Commission of Architectural Review

4. COA-176760-2025	Final Review	Meeting Date: 12/16/2025
Applicant/Petitioner	Jason Norfleet	
Project Description	Construct a rear ADU	
Project Location		
Address: 1111 West Franklin Street		
Historic District: West Franklin Street		
<p>High-Level Details:</p> <p>The applicant proposes to construct an semi-attached ADU at the rear of an existing building.</p> <p>The proposed ADU will be 26ft. in height, and 25ft. wide. It will have a gable roof with end parapet walls. It will be clad in tan brick and fiber cement panels.</p>		
Staff Recommendation	Approval, with Conditions	
Staff Contact	Alex Dandridge, Alex.Dandridge@RVA.gov, (804)646-6569	
Previous Reviews	<p>This application was approved conceptually at the November 2025 meeting. Specifically, the commission agreed with staff's recommendations concerning the rehabilitation of the primary buildings. Members agreed with staff conditions related to the ADU's roof form, noting that the proposed hip roof may read as incomplete if the units are not constructed concurrently, or if only one of them comes to fruition. The commission believed the roof form may benefit from being brought down further, an

Figure 1. Rear of property as seen from the alley. November, 2025.

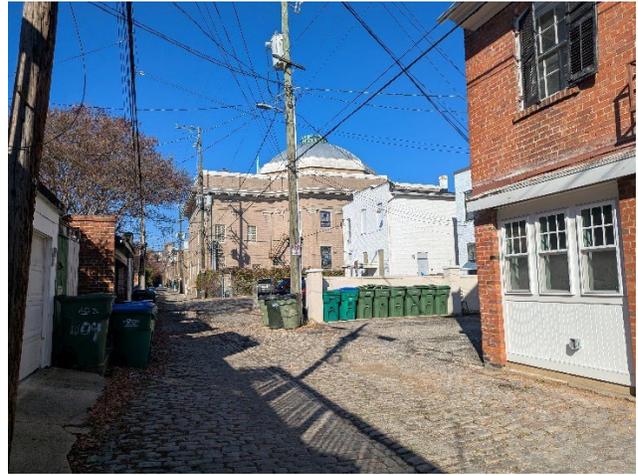
<p>contemporary design, while the roof form and parapet walls reflect the historic character of the district.</p> <p>There is one other two-story accessory building on the subject alley located at 1103 West Franklin Street. This ADU features full-sized windows on the alley elevation, and small windows on the side elevation. It also features a similarly designed end parapet wells as what is being proposed for the new ADUs.</p> <p>The new ADU will have similar small windows on the side elevations. While staff usually recommends full-sized windows, staff finds the proposed smaller side windows to be appropriate, as they are a contemporary take on the accessory building at 1103 West Franklin Street.</p> <p><u>During the conceptual review, the commission also asked for clarity on the location of the trash receptacle. A site plan indicates that they will be located in a small space on the side of the building.</u></p>
